## ADDED FEATURE

A Spacer has been added to Antenna Ass'y to provide a positive electrical contact with a variety of PCTEL & competitors mounts (FIG. 1).

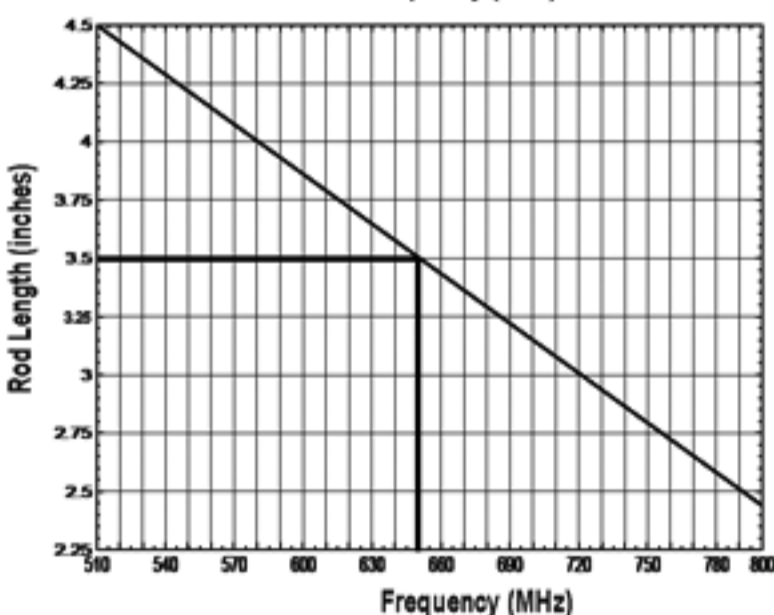
The Spacer allows a proper compression of Neoprene Washer at the interface of the Chrome Nut and Ground Plane (FIG. 2).

FIG. 3 (Antenna Mounted to Ground Plane)

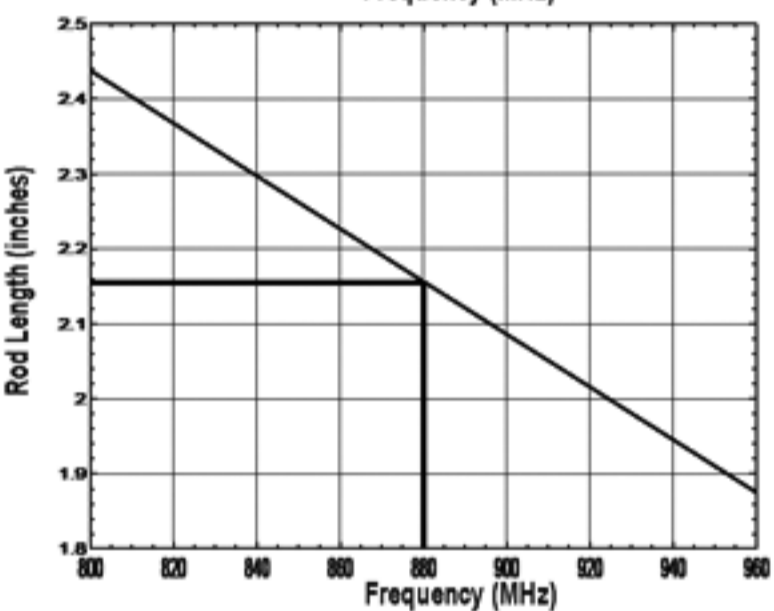
Should an additional compression of Neoprene Washer be necessary (FIG. 3), the Spacer (located in the cavity of the Insert) may be cut across and removed provided that an electrical contact is maintained.
